## Discretionary Review Abbreviated Analysis HEARING DATE: MARCH 15, 2018

*Date:* March 8, 2018  
*Case No.:* **2016-014004DRP**  
*Project Address:* **2865 Vallejo Street**  
*Permit Application:* 2016.10.11.9920  
*Zoning:* RH-1(D) [Residential House, One-Family (Detached)]  
40-X Height and Bulk District  
*Block/Lot:* 0958/017  
*Project Sponsor:* Lewis Butler  
Butler Armsden Architects  
1420 Sutter Street, First Floor  
San Francisco, CA 94109  
*Staff Contact:* Brittany Bendix – (415) 575-9114  
[Brittany.bendix@sfgov.org](mailto:Brittany.bendix@sfgov.org)  
*Recommendation:* **Do not take DR and approve as proposed**

Discretionary Review Hearing  
Case Number 2016-014004DRP  
2865 Vallejo Street

A - Before and After Images From Krooss (2868 Vallejo) Top Floor

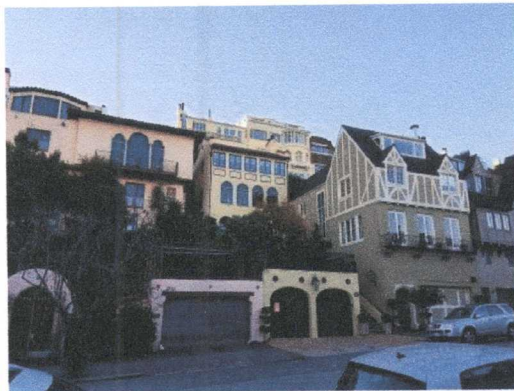
We live at [2858 Vallejo St.](#), across the street from a proposed addition at [2865 Vallejo St.](#) We are very opposed to their plan to expand their building envelope by 12 feet in height. We believe this will destroy the rhythm and beauty of our block. The houses now form a uniform step up to Broadway with large open spaces separating the blocks and similar heights. This is a formula that creates the unique look of many charming San Francisco neighborhoods. It also is respectful of neighbors open space and light. We believe this is contrary to agreed upon guidelines for our neighborhood and are hopeful this will not be allowed.

EXISTING / PROPOSED VIEW FROM PUBLIC REALM - VIEW 01

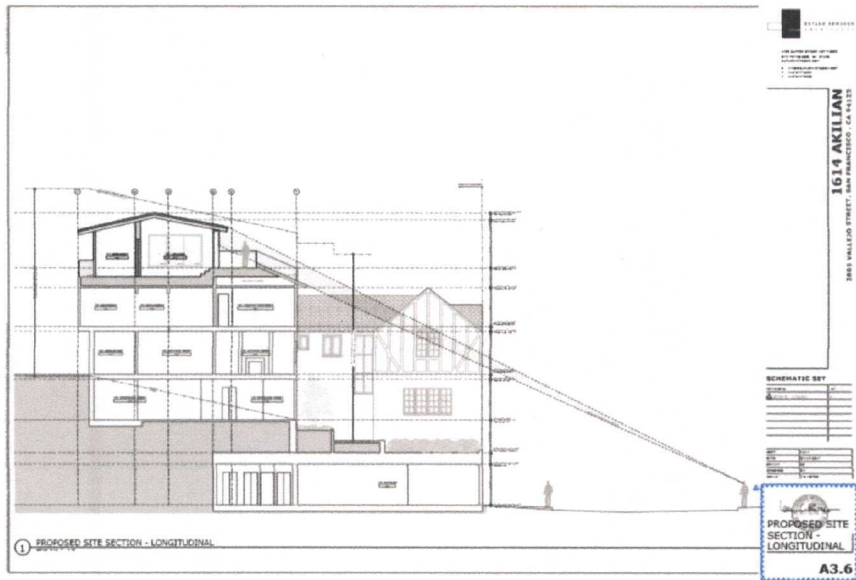
5. Renderings of the Public View from the street (See Images F - Public View Rendering Issue) supplied in support of the permit application are confusing and potentially misleading. The depiction of the public view of the addition to 2865 appears as smaller than it actually would be as can be seen in the corrected rendering. This discrepancy is very obvious when viewed from the street, and any physical site survey would clearly show this deviation. Obviously, the effect of this disparity is to minimize the disruptive impression of the addition to 2865.

Note: Rendering of top level view appears to be inaccurate as can be seen by (1) comparison to the height of the chimney pipe of 2853 which is approximately the same height as the top of the windows of the new addition on 2865 and at the same set back, and (2) analysis of the site section drawing below provided by the architect which shows the cross section of the projected view of the new addition to be approximately 5 to 6 feet, as shown in the corrected rendering above.
